**RE: Easton Commerce Park – Land Use of Regional Significance  
Wilson Borough, City of Easton and Palmer Township  
Northampton County**

Re: Easton Commerce Park  
Plans Dated April 1, 2024  
Wilson Borough, Palmer Township and City of Easton  
Northampton County

# LVPC ACT 167 REVIEW CHECKLIST

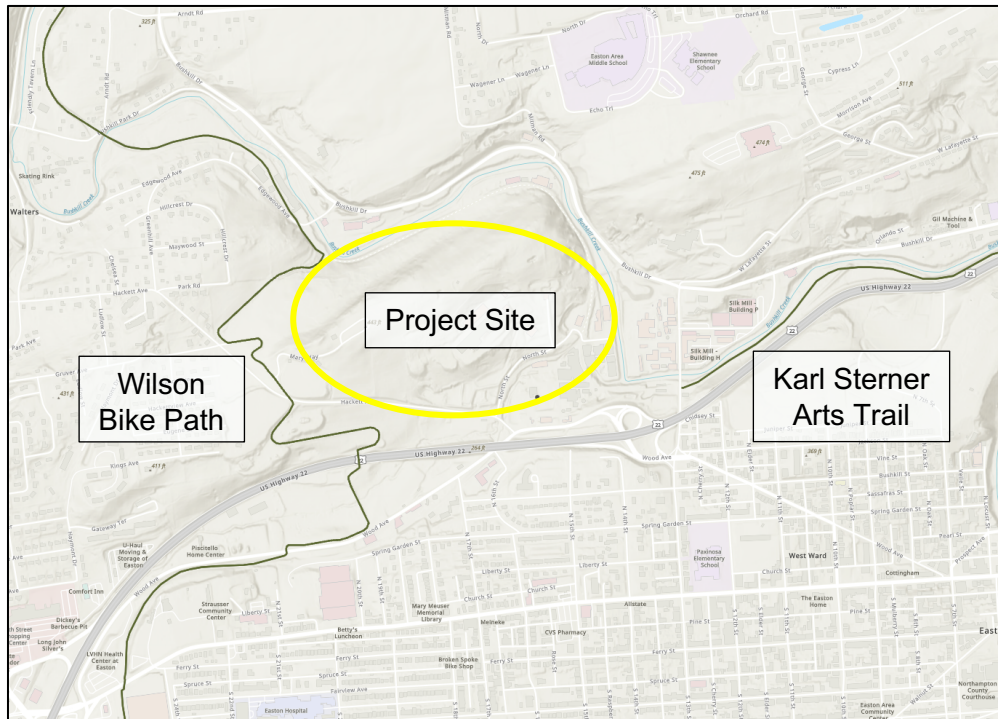
It is paramount that truck routing is specifically provided in the westbound direction on Hackett Avenue to prevent freight impacts to Hackett Park and the residential neighborhoods in Palmer Township to the northwest. If truck drivers need to travel to the north, GPS routing may utilize Tatamy Road to access Route 33. The LVPC recommends the proposed access drive on Hackett Avenue be restricted to left turn only for tractor-trailers to eliminate the possibility that trucks will be routed through local neighborhoods to minimize freight impacts (of Policy 2.4).
